ADDENDUM NO. 1

NOVEMBER 10, 2021

BIOTECHNOLOGY
BUILDING
THIRD FLOOR
LABORATORY
RENOVATION

2/A-102 Revised
ROOM #336
RENOVATION PLAN

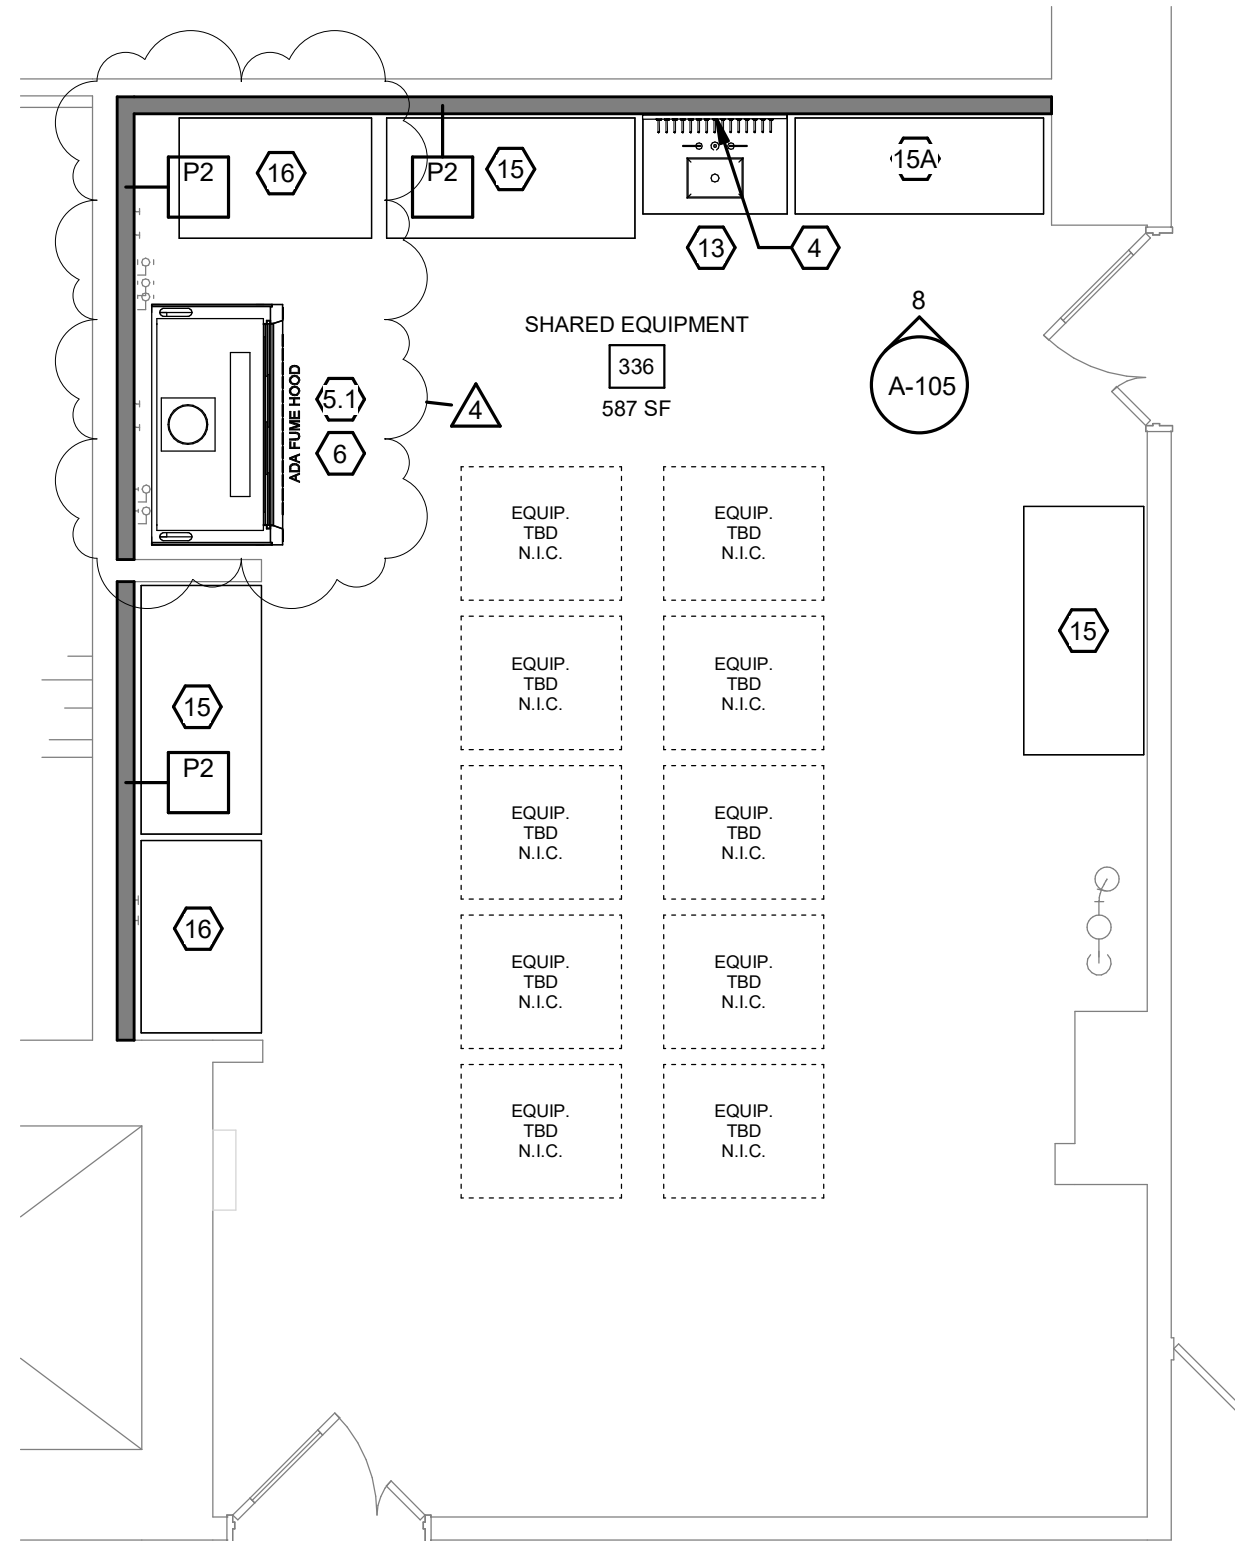
Item 5. Drawing A-102, Detail 2 – Room #336 Renovation Plan

DELETE Detail 2 in its entirety.

REPLACE with revised Detail 2, AD1-A1, attached.

RM. 354 ELECTRICAL
POWER & DATA PLAN

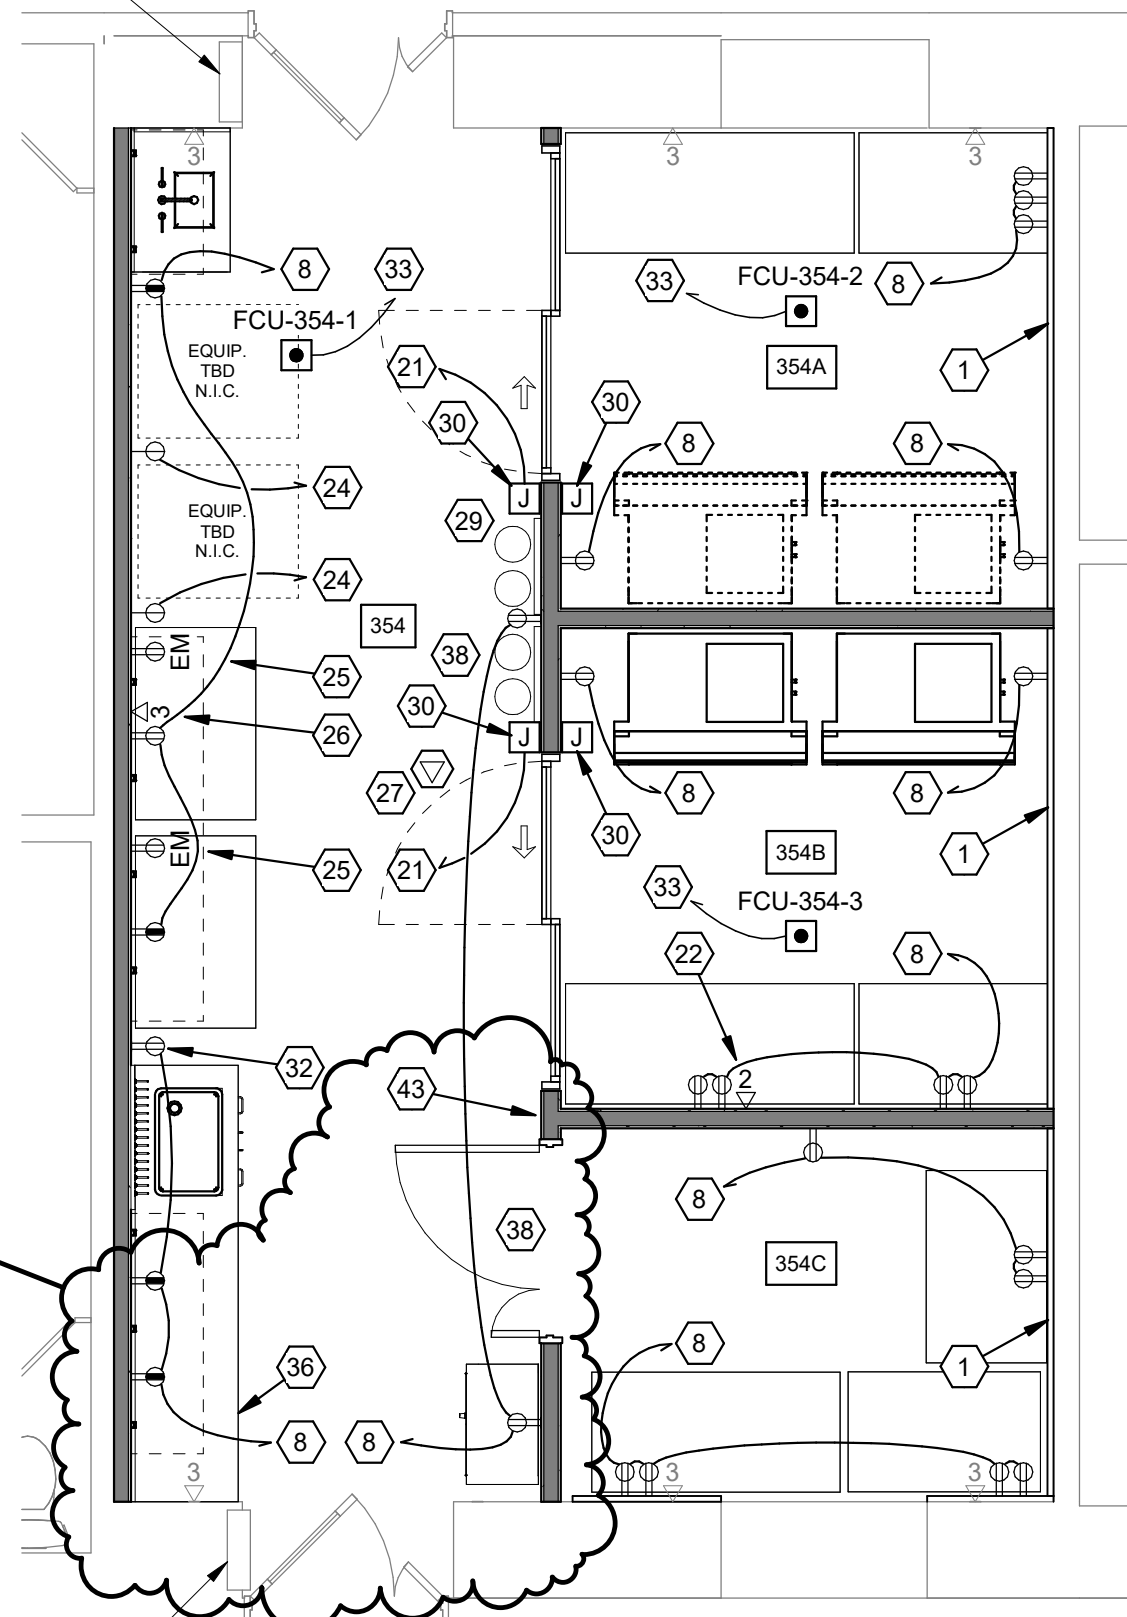
- 36 ELECTRICAL CONTRACTOR TO PROVIDE 120V POWER CONNECTION TO THE FAN LOCATED IN THE VACUUM CABINET. CIRCUIT TO NEAREST RECEPTACLE CIRCUITRY. INSIDE OF THE VACUUM CABINET, THERE WILL BE A 1.5 HP, 208V, 3 PHASE VACUUM PUMP BY OTHERS. ELECTRICAL CONTRACTOR TO PROVIDE HARDWIRE POWER CONNECTION. SEE NOTE 43.

- 43 AT LOCATION SHOWN, PROVIDE A SQUARD D MAGNETIC STARTER IN A NEMA 1 ENCLOSURE, CLASS 8536 TYPE SAG-12 WITH 3 MELTING ALLOY THERMAL UNITS NO. B10.2 TO CONTROL THE VACUUM PUMP LOCATED IN THE VACUUM PUMP CABINET. FROM STARTER, PROVIDE (4) 12 AWG & (1) 12 AWG GROUND IN 3/4" EMT TO PANEL UP-3E1, SECTION 2. INSIDE OF PANEL, PROVIDE A 20A/3P CIRCUIT BREAKER TO SUPPORT THE MOTOR STARTER. FROM MOTOR STARTER, PROVIDE (4) 12 AWG & (1) 12 AWG GROUND IN 3/4" EMT TO THE VACUUM PUMP. CONTROL WIRING BY THE CONTROL CONTRACTOR.

1 AD1-M1-ROOM #336 - MECHANICAL DUCTWORK DEMOLITION PLAN
SCALE: 1/4" = 1'-0"

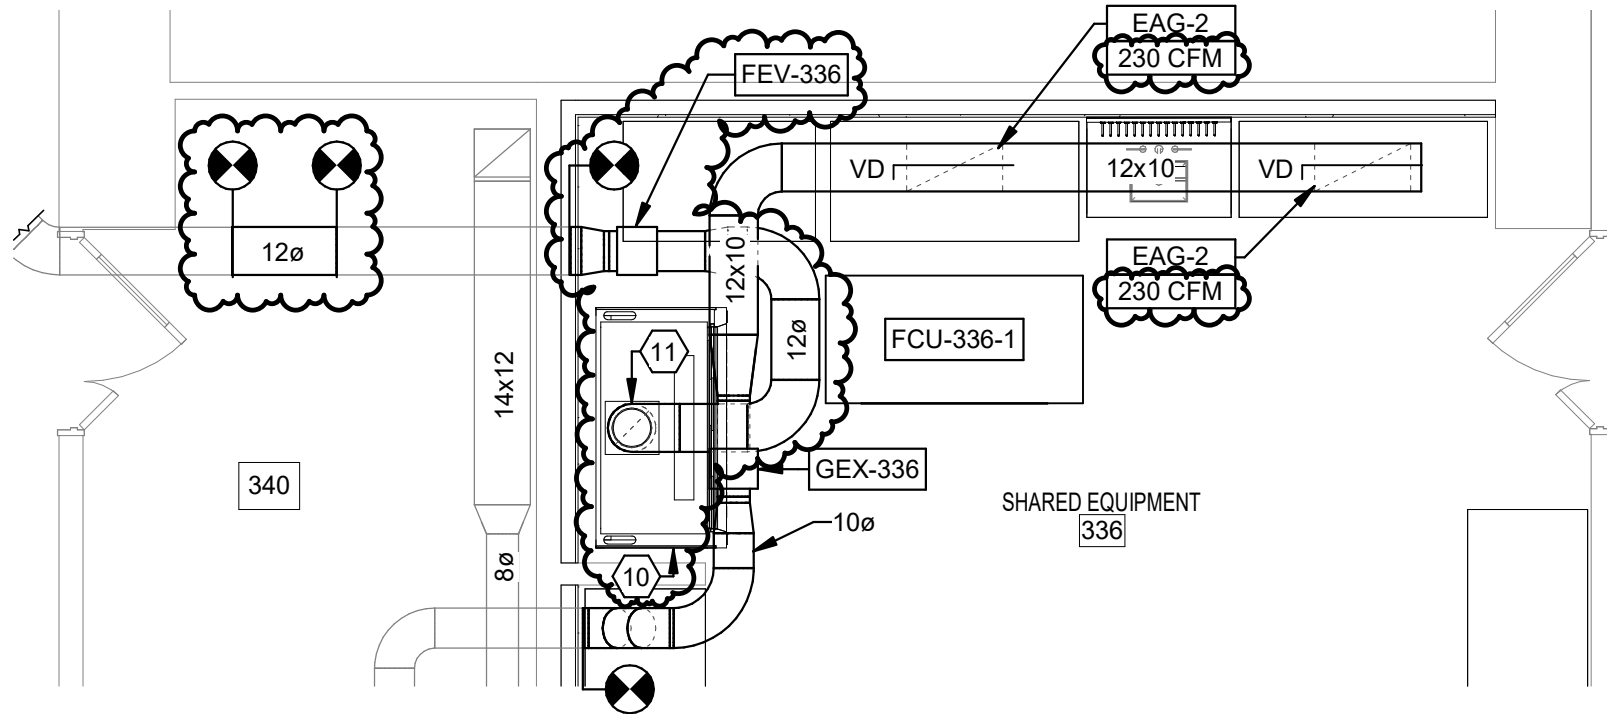
Item 11. Drawing M-101, Detail 2 – Room #336 – Mechanical Ductwork Demolition Plan

DELETE Detail 2 in its entirety.

REPLACE with revised Detail 1/AD1-M1 – Room #336 Mechanical Ductwork Demolition Plan, attached.

2 ROOM #336 - MECHANICAL DUCTWORK RENOVATION PLAN
SCALE: 1/4" = 1'-0"

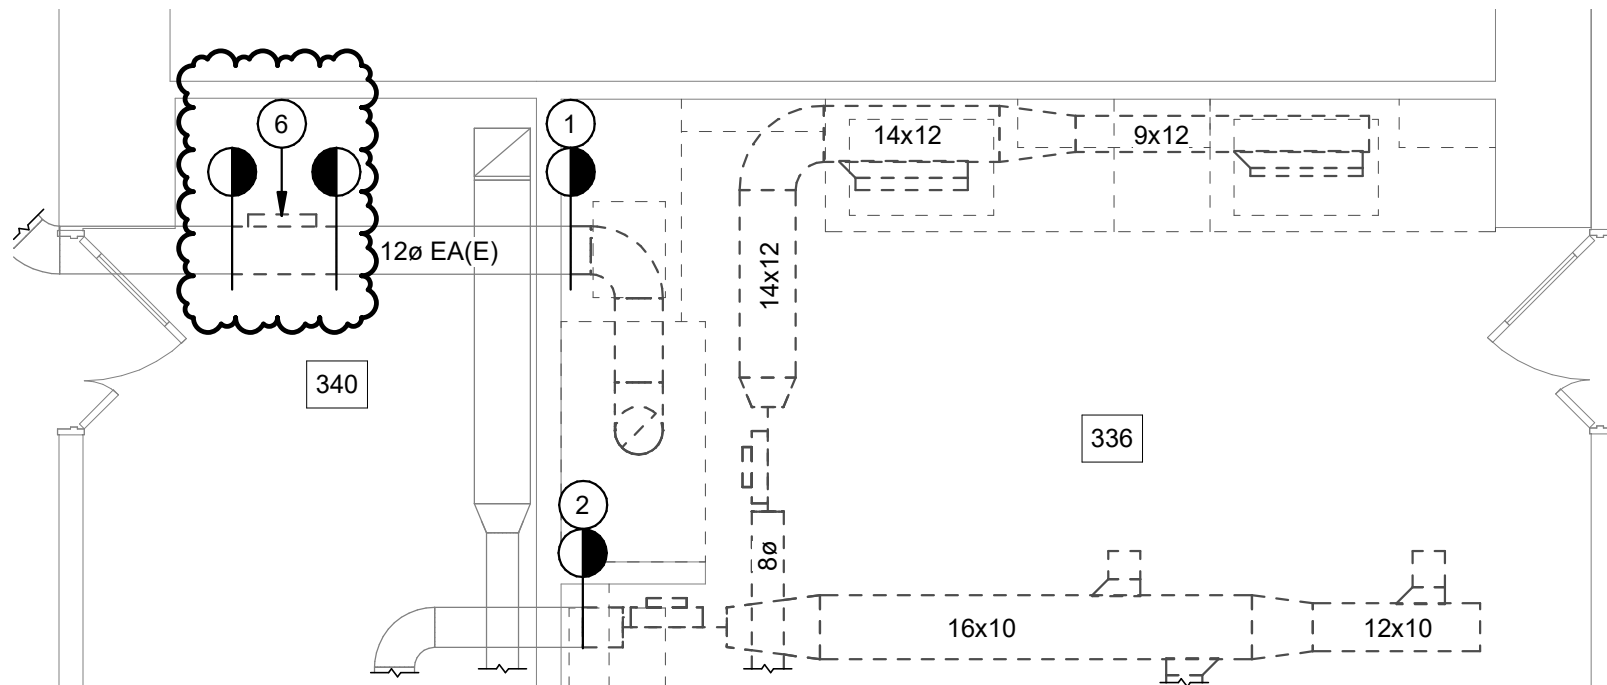
Item 12. Drawing M-103, Detail 2 – Room #336 – Mechanical Ductwork Renovation Plan

DELETE the Detail 2 in its entirety.

REPLACE with revised Detail 2/AD1-M1 – Room #336 Mechanical Ductwork Renovation Plan, attached.

1 PARTIAL THIRD FLOOR - MECHANICAL PIPING RENOVATION PLAN
SCALE: 1/4" = 1'-0"

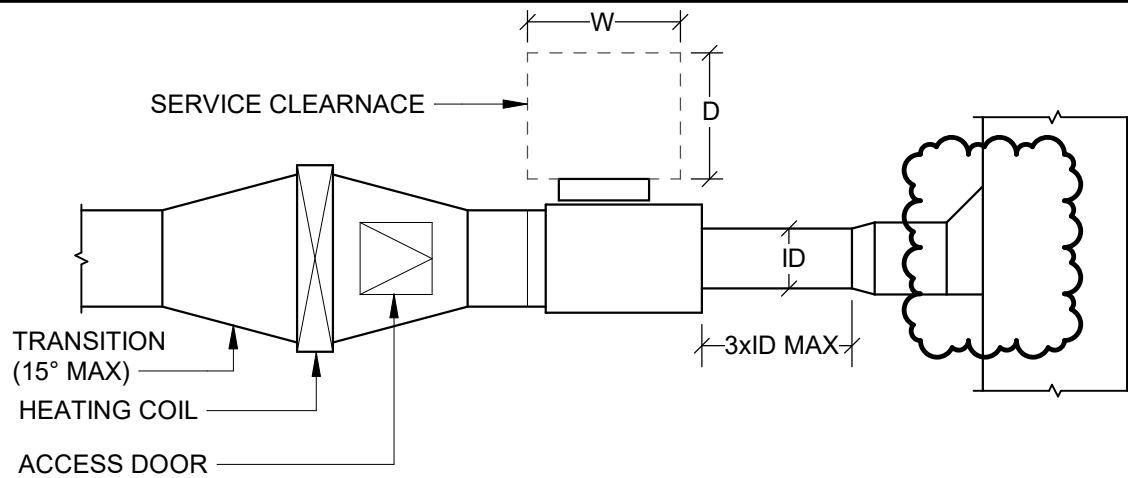
Item 13. Drawing M-104, FCU-354-1 located in Lab Prep 354

ADD fan coil unit condensate drain piping per revised Detail 1/AD1-M2 Partial Third Floor Mechanical Piping Renovation Plan, attached.

2 AD1-M2-AIR TERMINAL DEVICES
NOT TO SCALE

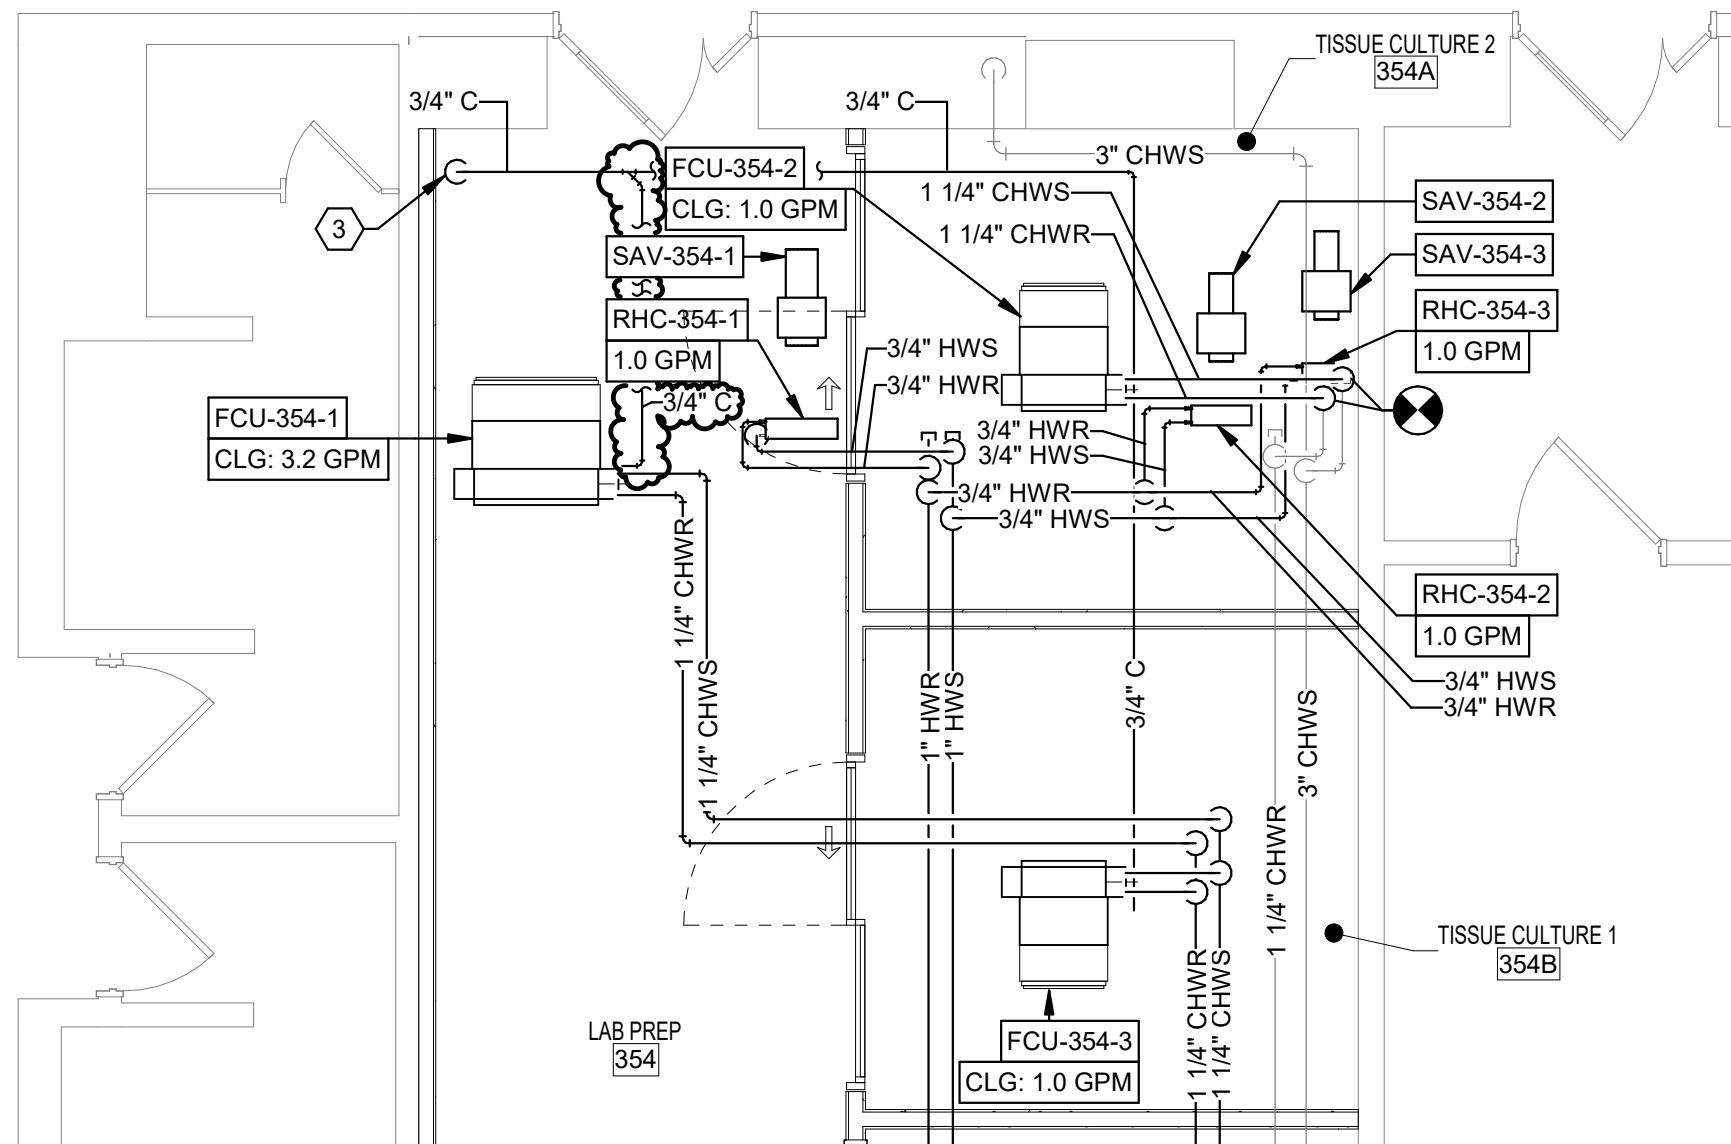
Item 16. Drawing M-401, Detail 5 – Air Terminal Devices

DELETE the Detail in its entirety.

REPLACE with revised Detail 2/AD1-M2 Air Terminal Devices, attached.
